MEETING LOCATION CHANGE
CITY OF CODY
PLANNING, ZONING AND ADJUSTMENT BOARD AGENDA
TUESDAY, JUNE 27, 2023 AT 12:00 P.M. (NOON)
CITY AUDITORIUM 1240 BECK AVE, CODY, WY

**CITY OF CODY
PLANNING, ZONING AND ADJUSTMENT BOARD
STAFF REPORT**

MEETING DATE:	JUNE 27, 2023	TYPE OF ACTION NEEDED	
AGENDA ITEM:		P&Z BOARD APPROVAL:	X
SUBJECT:	SPECIAL EXEMPTION: HEIGHT OF STEEPLE FOR THE CODY WYOMING TEMPLE OF THE CHURCH OF JESUS CHRIST OF LATTER-DAY SAINTS. SUP 2023-08	RECOMMENDATION TO COUNCIL:	
PREPARED BY:	TODD STOWELL, CITY PLANNER	DISCUSSION ONLY:

CITY OF CODY PLANNING, ZONING AND ADJUSTMENT BOARD STAFF REPORT			
MEETING DATE:	JUNE 27, 2023	TYPE OF ACTION NEEDED	
AGENDA ITEM:		P&Z BOARD APPROVAL:	X
SUBJECT:	CODY WYOMING TEMPLE OF THE CHURCH OF JESUS CHRIST OF LATTER-DAY SAINTS. FILE NOS: SPR 2023-13, SUP 2023-08 (BOTH CUP AND SE) AND FNC 2023-01	RECOMMENDATION TO COUNCIL:	
PREPARED BY:	TODD STOWELL, CITY PLANNER	DISCUSSION ONLY:

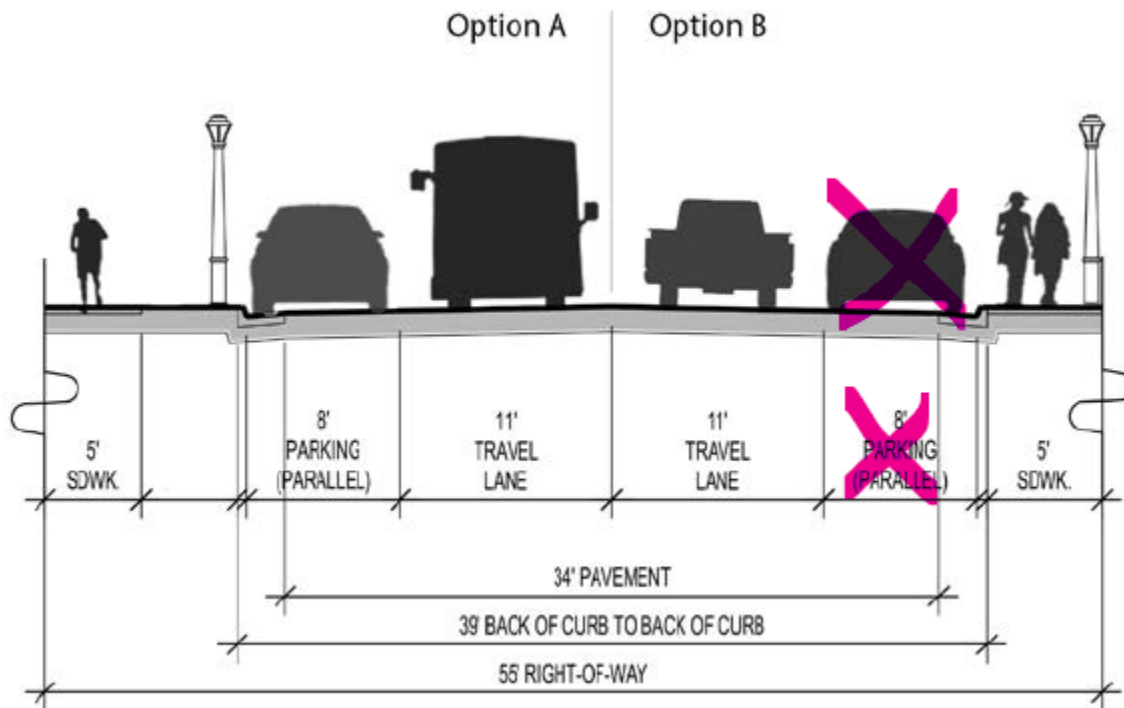
The proposed access situation is shown on the site plan. A new street, to be known as "Temple View Lane" will be constructed from Skyline Drive, along the south boundary of the temple site, ending in a cul-de-sac bulb. Two accesses to the temple site will be from that new street, as shown. Although the eastern temple access is on City right-of-way, City staff have indicated their preference that that section be privately maintained, to which the applicant has verbally agreed. With the designation of private instead of public, staff recommends a memorandum of understanding, simply outlining that it is a private improvement, with no maintenance responsibility for the City, and that if the right-of-way is ever developed with a public street, the party constructing that street would have the right to remove and/or reconfigure that access as needed, working in good faith with the property owner. Current City staff put the probability of that right-of-way being improved with a public street as extremely close to zero—way too costly and way too constrained by existing utilities and topography to justify such minimal traffic circulation benefit.

As the temple site has abundant on-site parking, there is no justification for requiring on-street parking along the north side of Temple View Lane. However, width for on-

street parking will be provided on the south side of Temple View Lane. Due to safety reasons (e.g. sight distance around the curve of Temple View Lane), there will be no parking in the intersection area of Temple View Lane and Skyline Drive—the street width is not designed in that area to provide parking on either side.

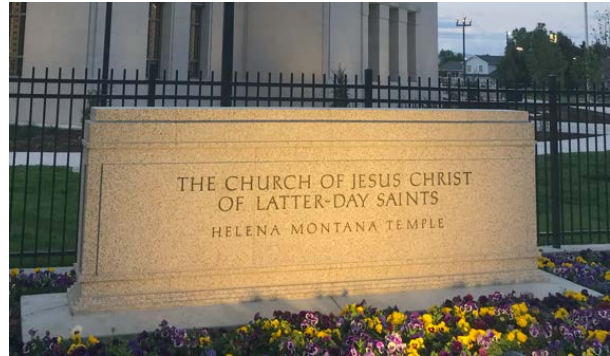
It is first noted that the sewer and water mains proposed under Temple View Lane relate to the subdivision of the Nielson property, not necessarily the temple project. However, if those lines are installed early enough for the temple to use them, it could allow for some efficiencies in the water lines, and perhaps other utilities.

While City staff (P.W. and Planning) are generally okay with the utilities as proposed, we are open to modifications that may result from the following requirements and suggestions.

- a) The fire marshal states that one additional fire hydrant should be added to the temple site and one at the end of the cul-de sac. The additional hydrant for the temple site is recommended to be in the island near the fire line valving directly east of the temple building.
- b) If desired, the stormwater piping may be able to be reduced by relying more on gutter flow in the street entrance areas. In addition, the pipe to the ravine seems larger than needed.
- c) Black Hills Energy requests additional separation between the proposed natural gas line and the perimeter fence and electrical line. That could involve adjusting things a few feet, or just moving the gas line to the south side of Temple View Lane.

The electrical plan generally appears fine, but is missing the line from the existing fuse cabinet to the proposed transformer next to Skyline Drive. Also, shift the proposed transformer slightly to allow room for a future sidewalk along Skyline Drive (min. 5 feet behind back of curb.)

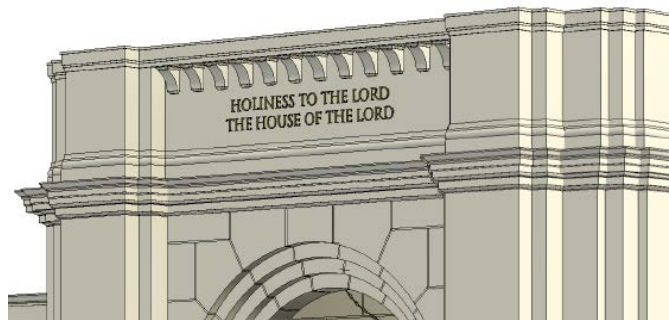
The City sign code simply states that all signs for churches must be approved by the Planning and Zoning Board. There are no limits on number, height, or size. At the entrance there would be a monument sign, similar to the Helena temple sign shown here. Staff has no concerns with the sign itself, but would ask that the illumination not be as bright as the Helena sign. Other small directional and convenience signs, such as address numbers, building nameplates, ADA parking signs, etc. would also be installed.

The statement "Holiness to the Lord, the House of the Lord" above the entry of the temple is simply considered constitutionally protected non-commercial free speech.

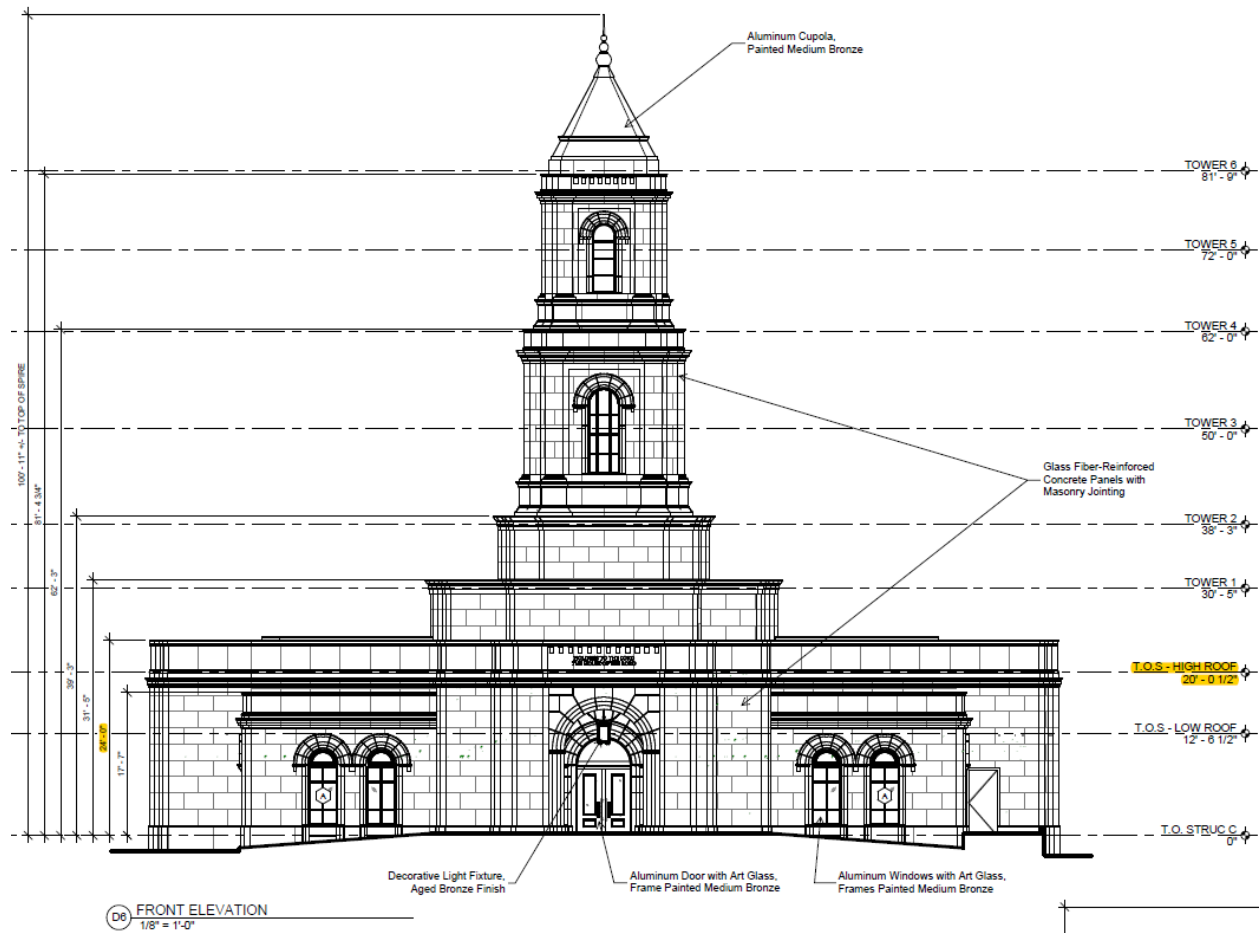
Now we must analyze whether the temple complies with the “maximum building height” standard, which is 30 feet.

First, notice that building height is not necessarily the highest point of a building. For example, on sloped roofs building height is measured only to the midpoint between the eave and ridge of the main roof. More than one home in the immediate proximity of the proposed temple can be used to illustrate the point. However, some of the materials that have been circulated relating to the temple project have not taken this into account—likely unintentionally. Correct information is necessary for a proper analysis.

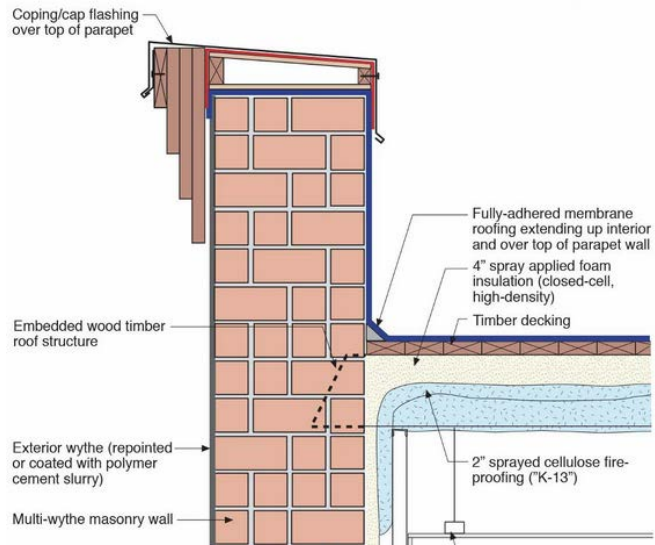
While I have not seen the building permit set of plans for the Cody temple, the architect has recently stated that the roof and steeple concept used for the Cody temple is almost exactly the same as the Helena temple, differing only in the shape of the steeple. What I discovered while viewing a time-lapse video of the Helena temple construction is that there is no roof or skylight (for those familiar with the Billings temple skylight) above the flat membrane roof that covers the main level of the building. The panels that visually form the base of the temple steeple are actually suspended by a steel framework above the roof of the temple and are entirely open vertically—rain and snow would fall all the way to the roof of the main level, which is below the 24-foot-tall parapet wall. The steeple base has no roof. The flat roof on the temple is immediately above the ceiling of the occupied space of the main level. No portion of the steeple contains space that is considered habitable or that would be occupied.

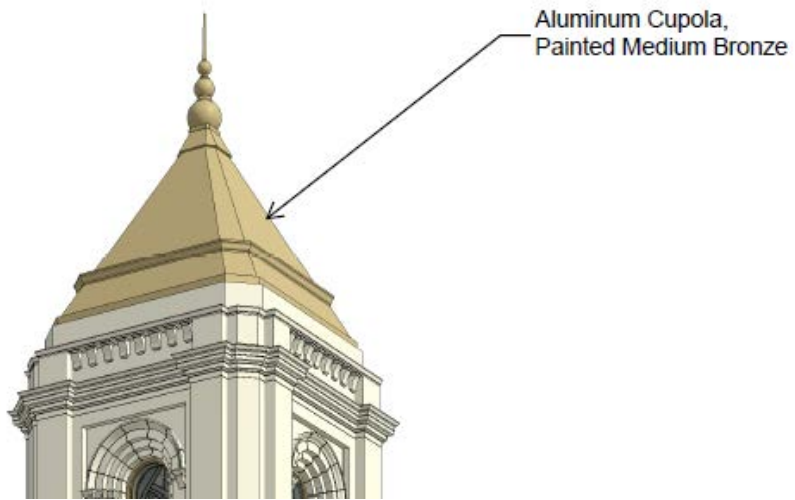
The cupola is technically a component of the steeple, but in the shape of a hip style roof, which may at first suggest that building height should consider the cupola. However, the cupola does not form the “main roof” of the building. Its size is only a small fraction of the flat roof below. As such, part “c” of the building height

definition—shown in context below, is not applicable, due to the cupola not being the main roof.
